ECR proudly announces the New and Improved *GTMA 3 Position Gas Furnace*. ECR International is committed to producing products that satisfy the needs of our installers and homeowners. This next generation of mid efficiency gas furnace is proof of that commitment.

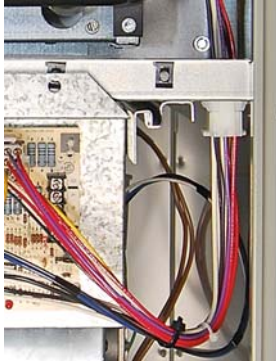
3. **New Integrated Furnace Control (IFC)** - constantly monitors all safety devices and controls all aspects of the furnace. The sophisticated control center contains L.E.D. service lights with 11 self-diagnostic service codes (5 more than smart valve II) to ensure quick and accurate service calls. Connection of additional home comfort products (air conditioning, electronic air cleaner and humidifiers) is easy with simple plug in connections. The IFC has been mounted between the blower rails so that it is easily accessible in upflow and horizontal positions. This also reduces potential vibration (some competitors mount directly to the blower), and the IFC can be detached without removing the entire blower assembly. The IFC is fused for protection of the board and transformer from electrical faults.
